1830 E Mercer Mixed-Use Building

DPD #3020860

Design Review Board Recommendation Meeting

Commercial Continuity

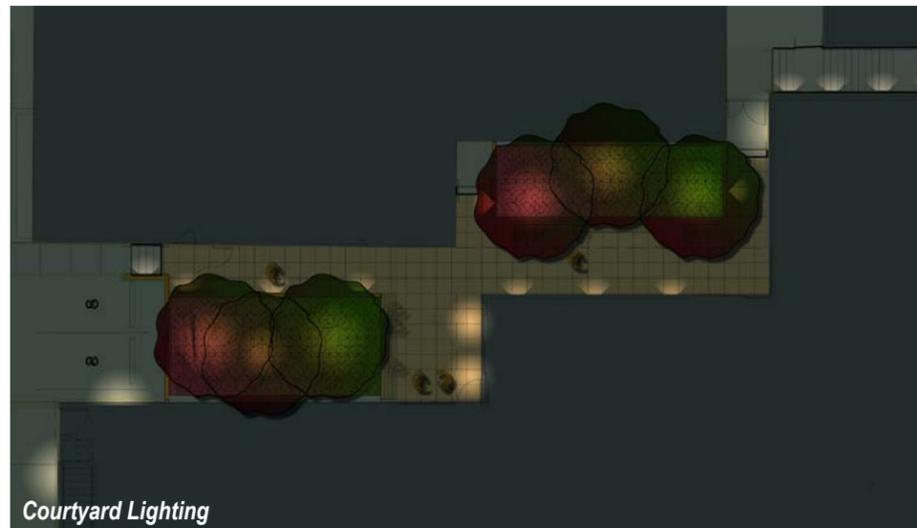
b. *Support the continuity of the commercial space at the existing building. (CS3.A.1)*

The proposal locates a continuous commercial space along 19th Avenue East from the corner to the existing restaurant to the north. The commercial space is set back 6' from the property line, providing a widened sidewalk and allowing interior uses to comfortably spill out. Floor-to-ceiling window walls with a high level of operability will reinforce the connection between inside and outside. The effect will be an enhanced pedestrian environment that extends the vitality introduced by neighboring establishments such as Tallulah's, Monsoon and Ernest Loves Agnes.

EXCEPTIONAL TREE

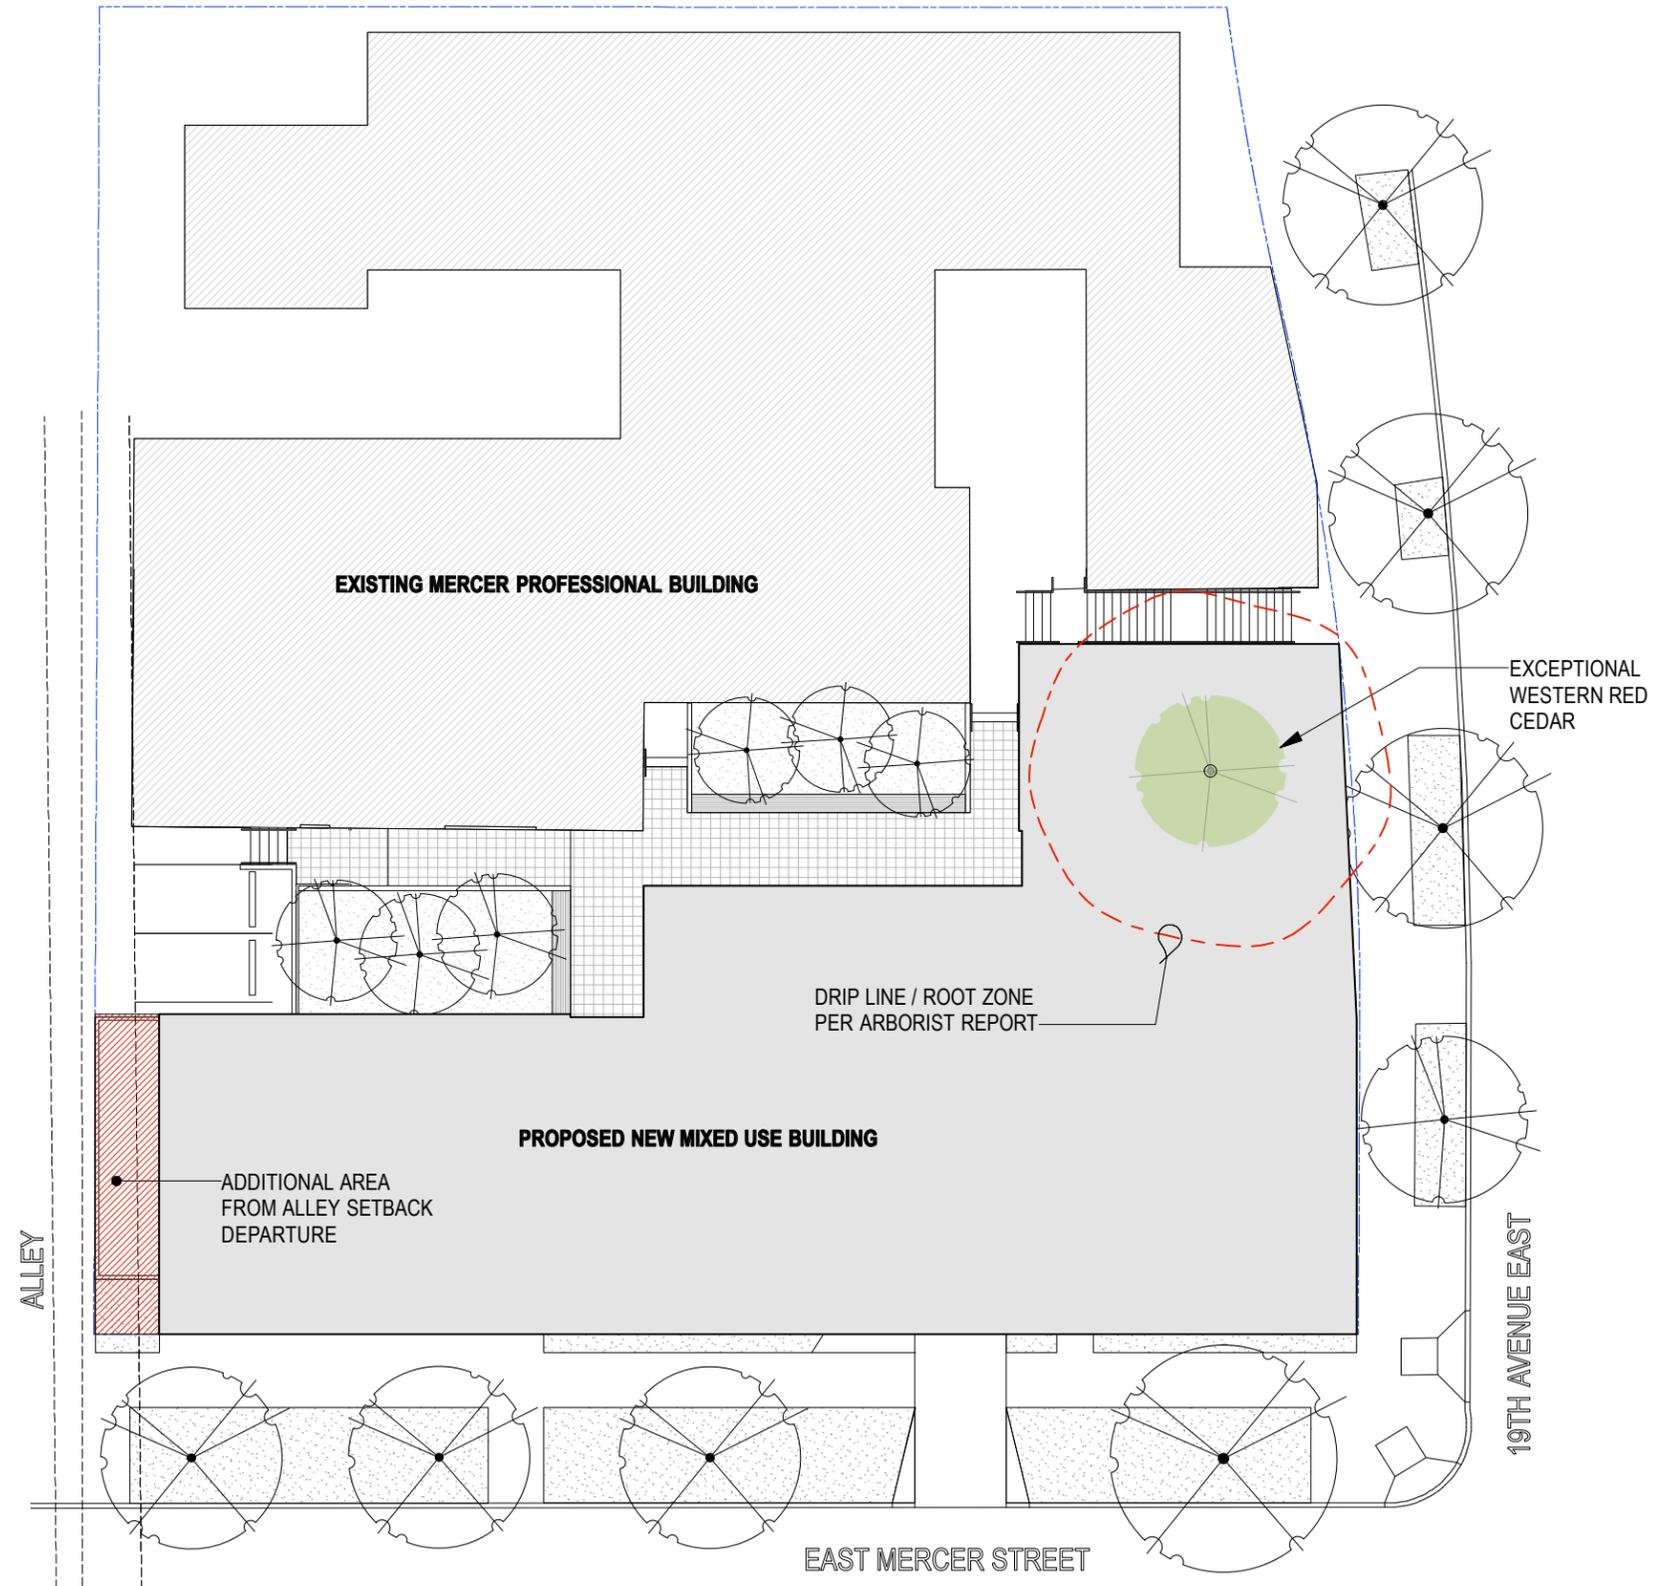
4. Cedar Tree along 19th Ave E: The Board was supportive of removing the tree and stated that a strong commercial frontage on 19th Ave E and at the site corner is preferable over saving the tree. However a strong streetscape including high quality landscaping must be provided. (DC4.D.4) [Staff note: if the arborist determines that the tree is exceptional and in good health, the Board will need to vote to recommend removal of the tree.]

SMC 23.11.080.A2 Tree Protection

The Director may permit an exceptional tree to be removed only if the applicant demonstrates that protecting the tree by avoiding development in the tree protection area could not be achieved through the development standard adjustments permitted in Section 23.41.018 or the departures permitted in Section 23.41.012, a reduction in the parking requirements of Section 23.54.015, and/or a reduction in standards of Section 23.54.030.

Allow removal of exceptional tree.

Power-line setbacks along the alley, fire-distance requirements for existing non-protected openings, and the preservation of access to existing building entry and egress points significantly limit the buildable area of the southern portion of the site. Parking is optional for this site and the only departable standard that would provide some compensation for lost building area is the rear setback. Even with relief from this standard, saving the tree is anticipated to reduce the number of dwelling units by 5 and reduce the commercial square footage by a third. Beyond project viability, the benefit of removing the tree is enhanced commercial continuity along 19th Avenue, connecting Monsoon restaurant to the intersection of 19th and Mercer and bringing additional vitality to the pedestrian experience, pursuant to Design Guidelines PL-2 and PL-3. The six Japanese Maples proposed in the new courtyard will provide the required replacement canopy. In addition, generous planting and four large trees will be added to the Mercer Street R.O.W., which is presently devoid of street trees.

Departure Request #1: SMC 23.47A.032 A1 Parking Access

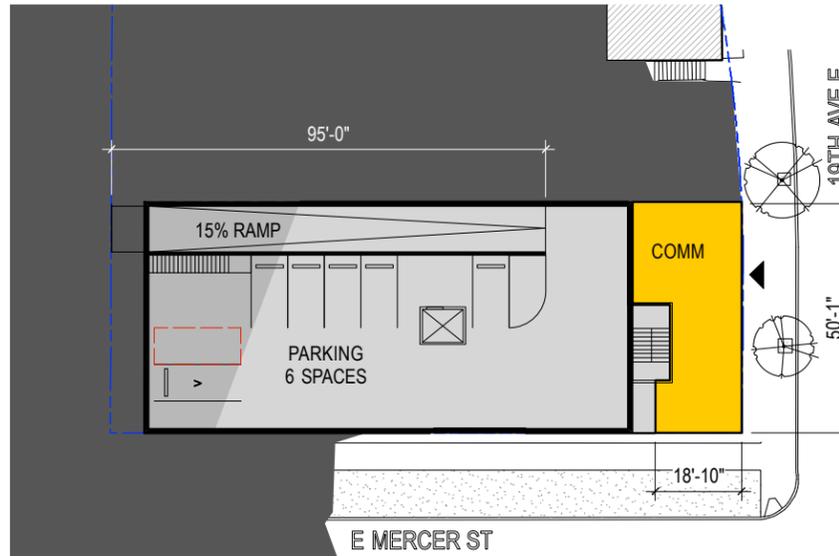
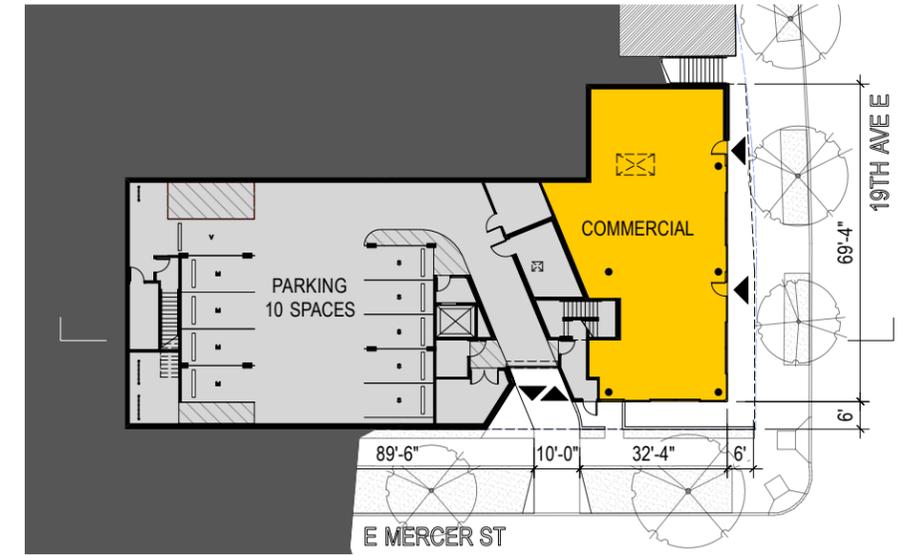
Access to parking shall be from the alley if the lot abuts an alley improved to the standards of Section 23.53.030C.

Allow access to the underground parking garage to be from E Mercer Street rather than the alley.

Due to the site topography, access to parking from the alley is impractical. With a drop of more than 14', a ramp in excess of 90' is necessary to maintain the code mandated 15% slope. The resulting parking garage is inefficient and accommodates only six vehicles as opposed to ten vehicles accommodated by the proposed scheme. Moreover, the extended ramp would compromise any commercial space along 19th Avenue. Average depth of well under 30' would require a design departure. Eliminating the commercial space is counter to Design Guidelines PL3 (Street-Level Interaction) and DC1-A (Arrangement of Interior Uses). Expanding the commercial space all the way to the property line instead of holding back the preferred 5' fails to recoup enough of the lost commercial area and misses the opportunity to provide a widened sidewalk, pursuant to Design Guideline PL2 (walkability). Eliminating the parking garage fails to meet the development objective and is counter to DC1-C, which encourages underground parking.

Departure Request #2: SMC 23.47A.032.B1.b Parking Location

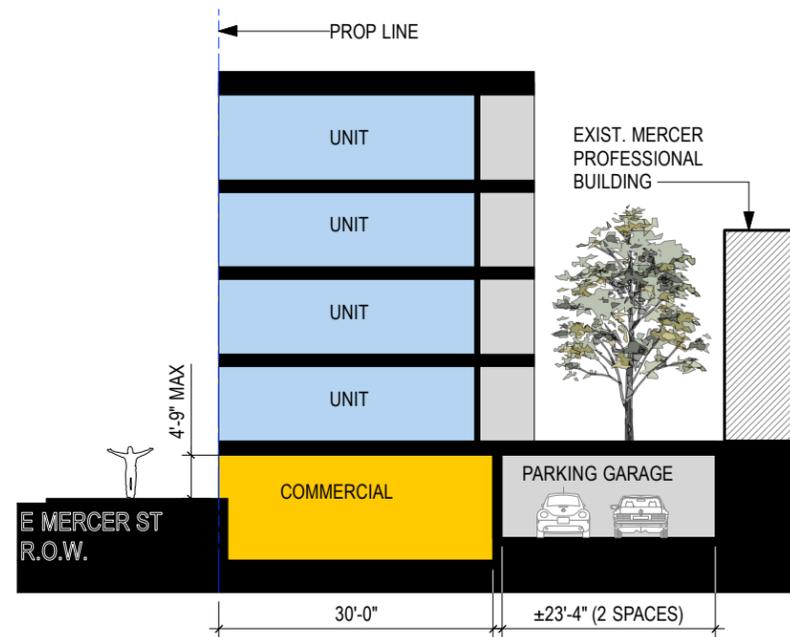
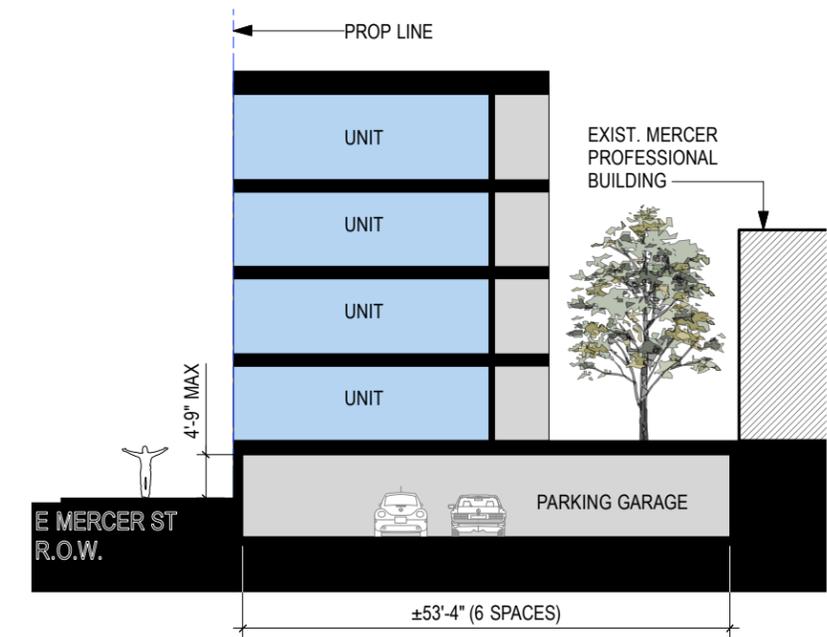
Within a structure, street-level parking shall be separated from street-level, street facing facades by another permitted use.

Allow the parking garage to extend fully to E Mercer Street.

Because the parking garage is below the second floor, it is primarily underground relative to East Mercer Street, which rises approximately 17' from the 19th Avenue Intersection to the Alley west of the subject property. Furthermore, the depth of buildable area parallel to E Mercer is very limited and cannot tolerate another use without rendering the parking garage unviable. There is a consistent pattern in the neighborhood of sloped east/west streets clipping lower levels. The design proposes an integrated brick screen wall, which will provide a secondary architectural feature and texture pursuant to DC2-C and DC2-D.

Departure Request #3: SMC 23.54.030 G1 Sight Triangle

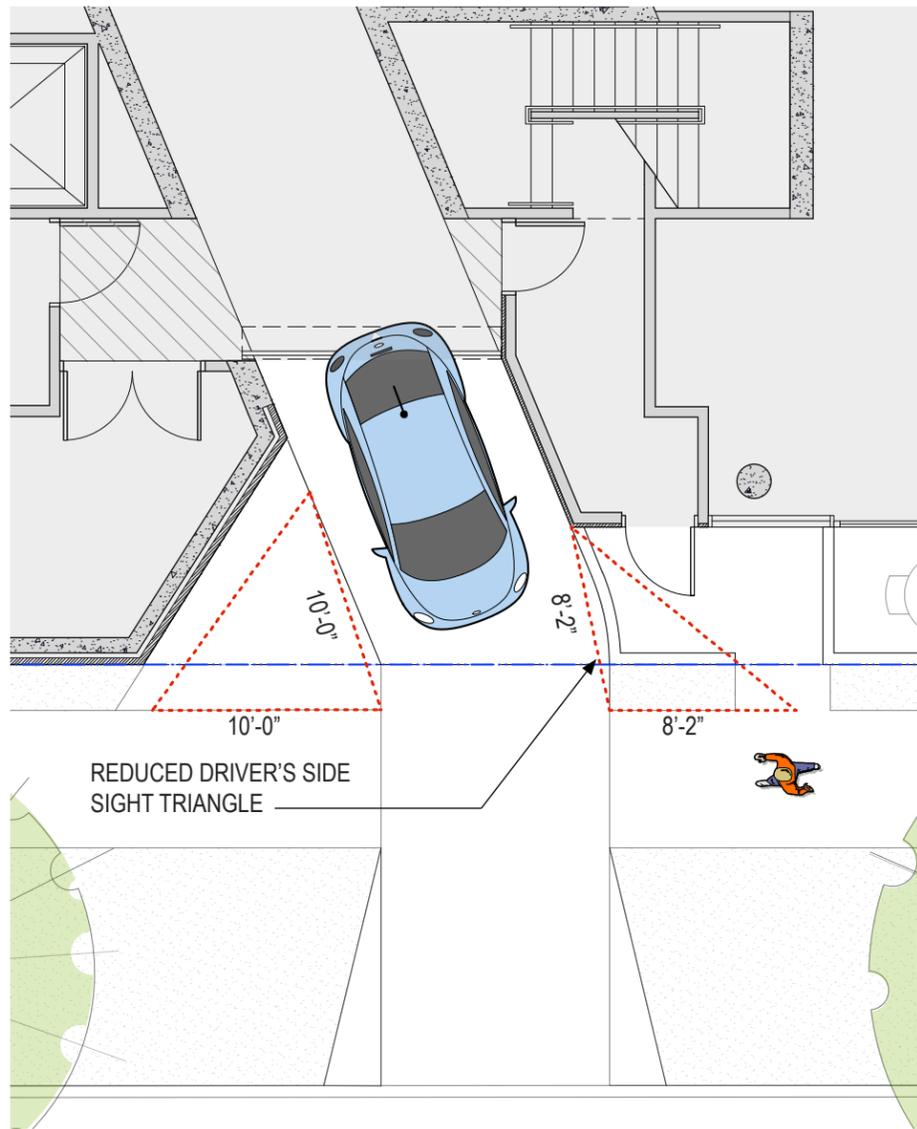
a. Consider reducing the sight triangles at the garage entry on E Mercer St. The Board indicated support for a departure to allow mirrors instead of full site triangles to reduce the size of the parking entry. (DC1.C.2)

For two way driveways less than 22 feet wide, a sight triangle on both sides of the driveway shall be provided, and shall be kept clear of any obstruction for a distance of 10 feet from the intersection of the driveway with a sidewalk.

In order to keep the visibility of the parking garage to a minimum, the applicant has requested a design departure to reduce the sight triangle requirement at the driver's side. Refer to Departure #3.

Allow for a reduction in driver's side sight triangle from 10' to roughly 8' and supplement with visual warning device and/or mirrors.

The proposed garage entry is set back from the street and angled relative to the surrounding building façade in a manner that preserves the passenger side sight triangle and most of the driver's side sight triangle, but subdues the presence of the parking garage entry pursuant to Design Guideline DC1-C-2. The modest reduction in driver's side sight triangle allows the width of the garage entry to be minimized.

Departure Request #4: SMC 23.46A.005 C1 Residential Uses Street Level

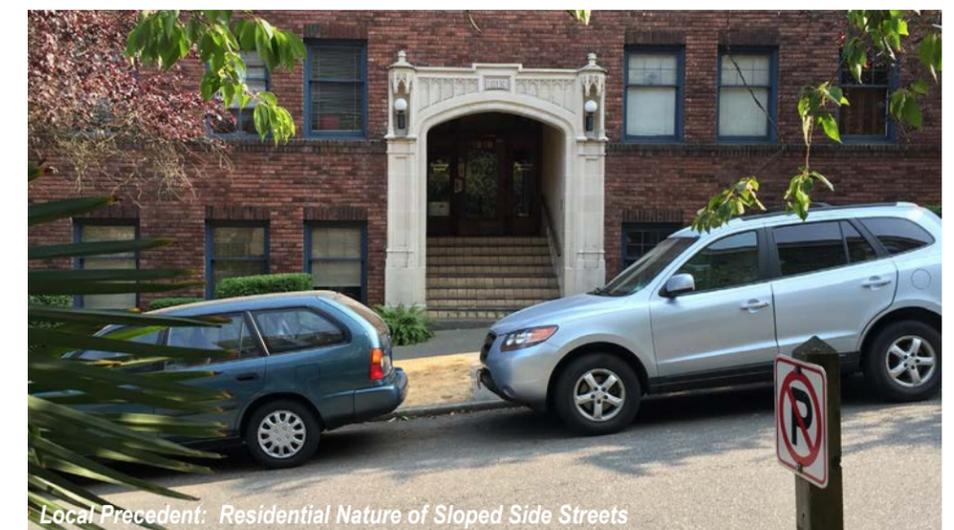
Within an NC1 zone residential uses may occupy, in the aggregate, no more than 20 percent of the street-level-street-facing façade.

Allow 78% of Mercer Street façade to be residential accessory uses, including lobby, bike storage, parking garage.

The slope of E Mercer poses a challenge to locating continuous and accessible commercial spaces along that edge. Nearby parallel streets are similarly sloped between 18th and 19th Avenue, and consequently there is an absence of commercial uses beyond the intersection with 19th. The proposed design wraps the commercial frontage around locates the parking garage and residential lobby at split-levels along the western three quarters of Mercer. This provides for a quieter street edge consistent with the more tranquil and residential nature of E Mercer and other neighboring sloped streets. By reinforcing this pattern, the proposed design is consistent with Design Guideline CS2-A-1.
